PRELIMINARY OVERALL AREA DEVELOPMENT PLAN
for
WOODLAND HILLS SUBDIVISION
"A Vance Jackson Joint Venture"

INFORMATION SHEET FOR
PRELIMINARY OVERALL AREA DEVELOPMENT PLAN
(P.O.A.D.P.)

Re: Woodland Hills

File #: 83-13-62-44

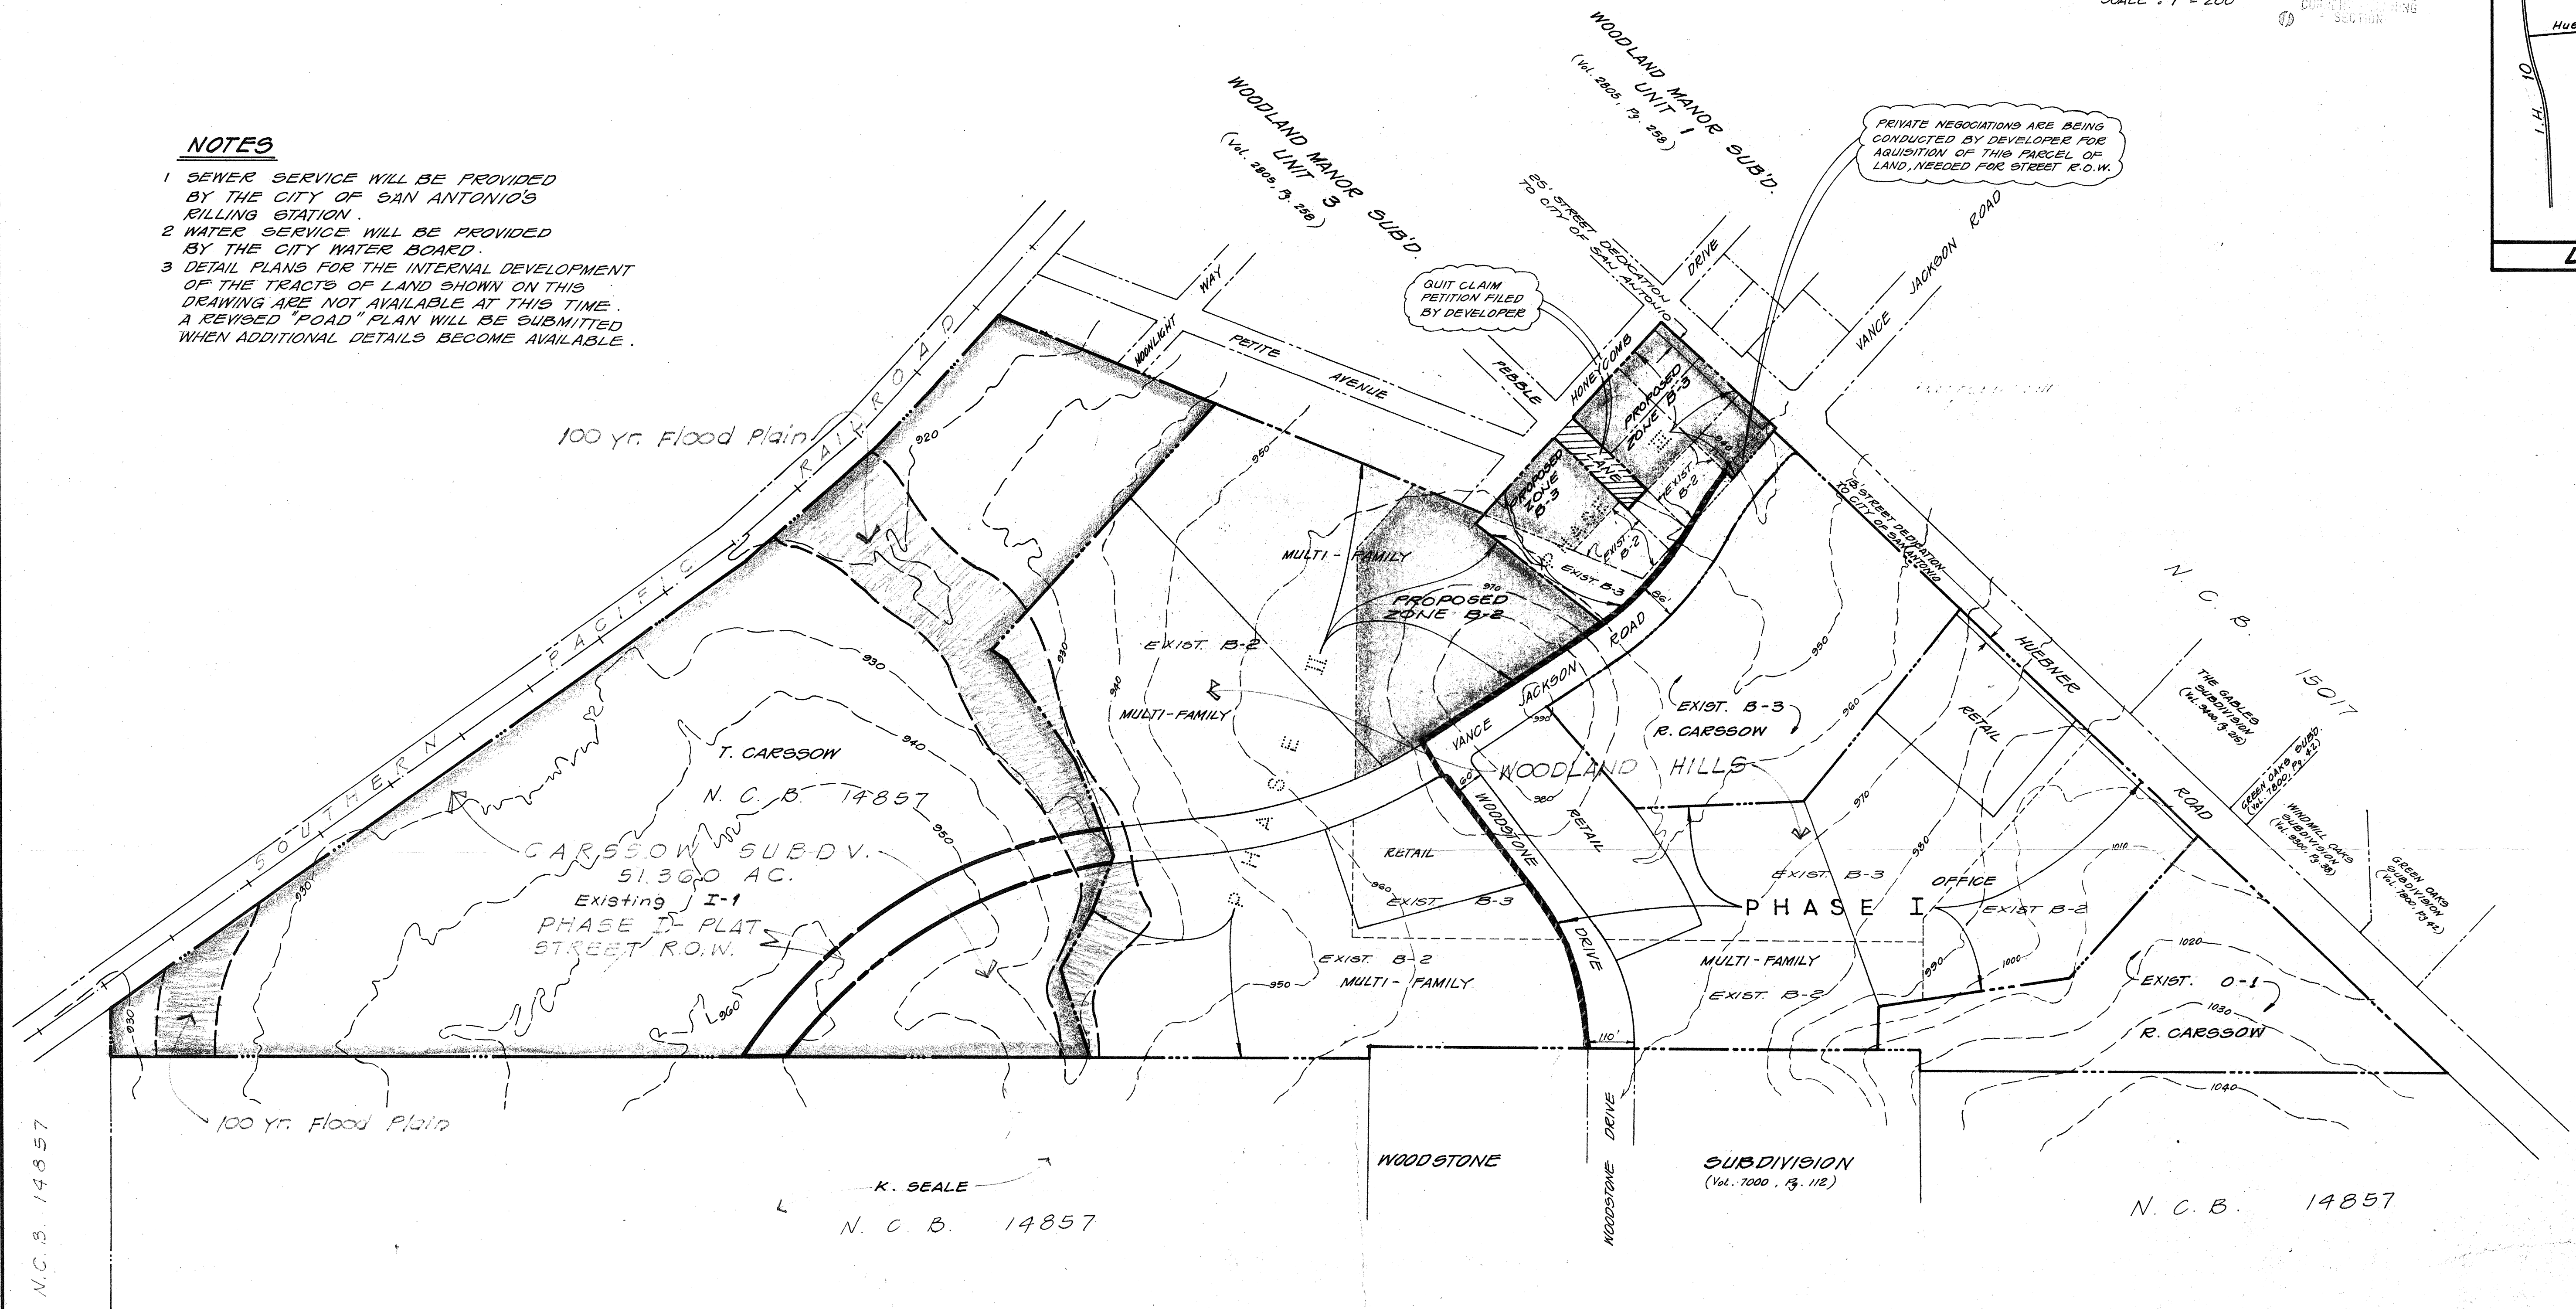
REVISED P.O.A.D.P.
ADDED CARSSOW SUBDIVISION
BY: BROWN ENGINEERING CO.
MARCH 13, 1985

DATE	DESCRIPTION	APPROVED	FILE LOCATION
4/4/84	REVISED PROPOSED ZONING LIMITS	A.A.G.	
4/2/84	ADDED PHASE III	A.A.G.

(xx) Comments: This acknowledges receipt of the revised
plan showing new alignment of Vance Jackson Road.

☒ (X) Comments: This acknowledges receipt of the revised
plan reflecting Phase III and the planned zoning for
the area.

PLAT OF

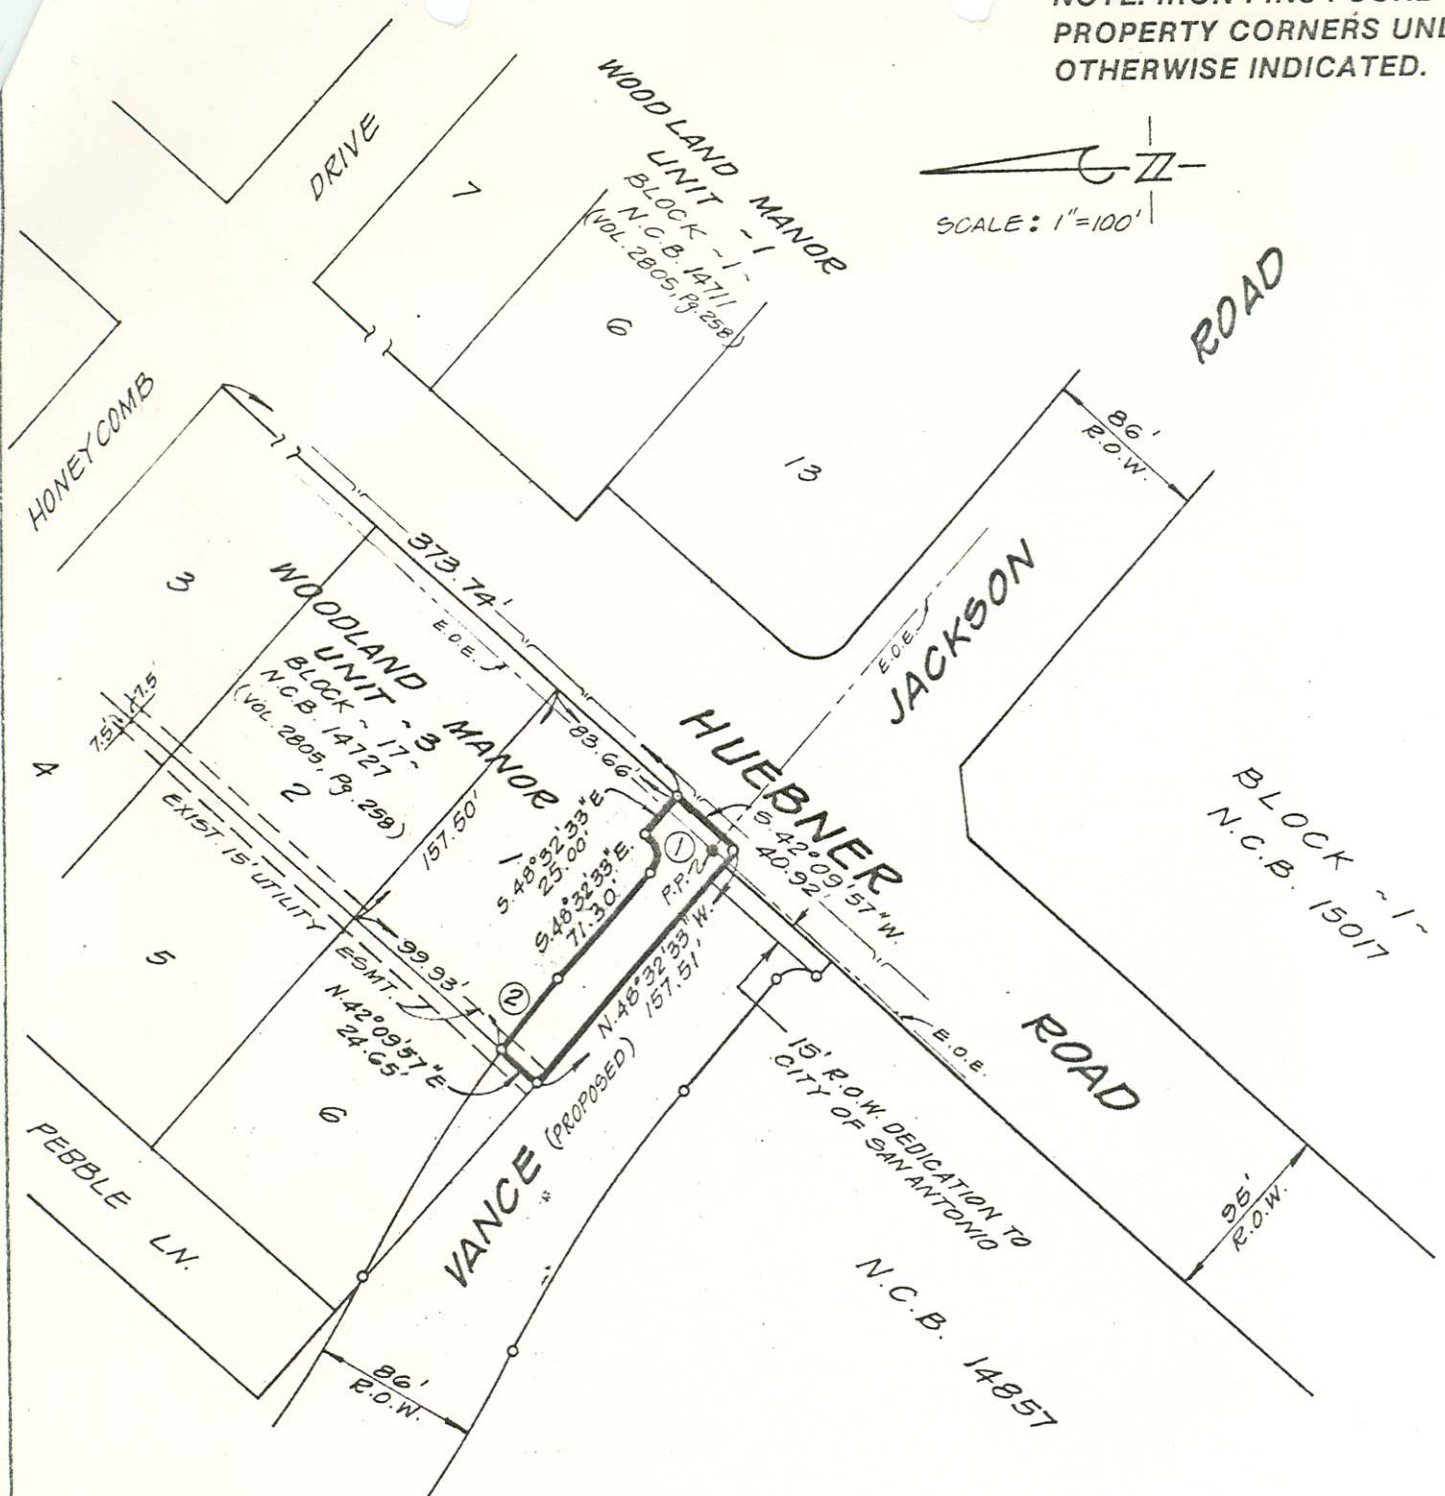
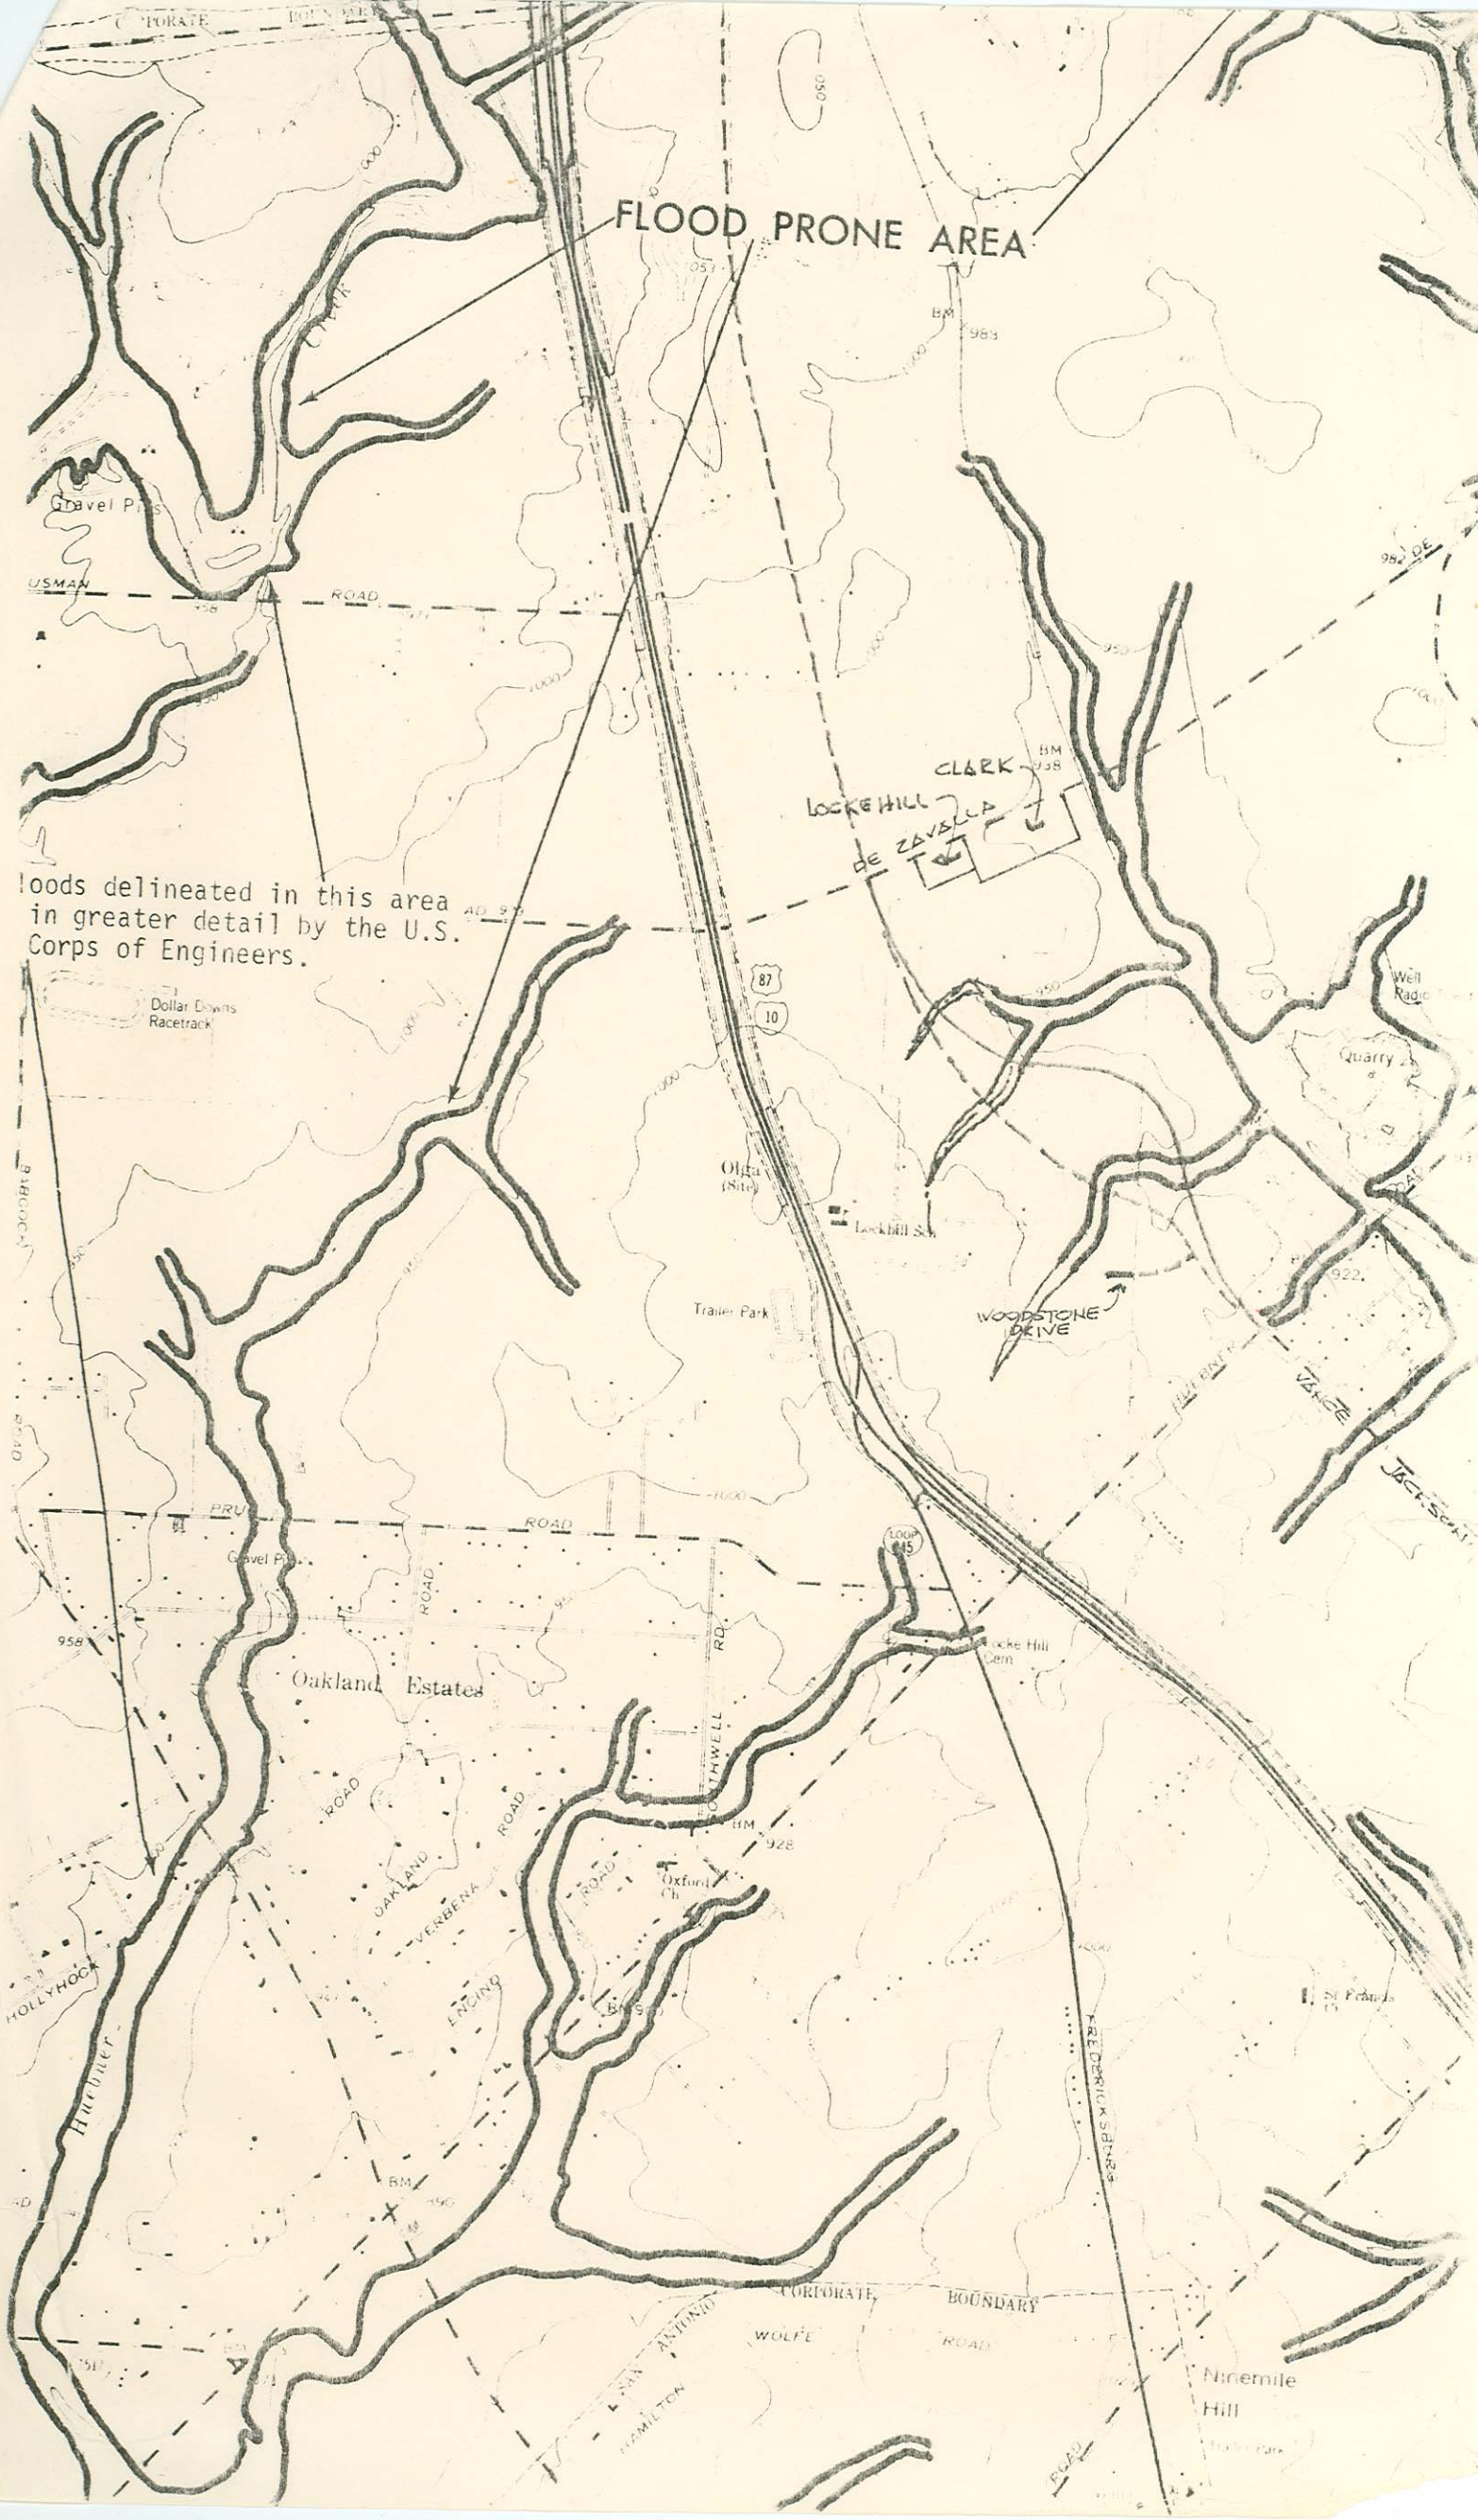
Hubner & Vance Jackson — Staff has no
problems with the new proposed alignment
which J.S. Brown has proposed. However, Fern
wants us to check if we have any existing
plattings adjacent near or around the proposed
Vance Jackson Rd. to the north. Also, Woodstone
Dr. should taper down to a 60' R.O.W. rather than
50'.
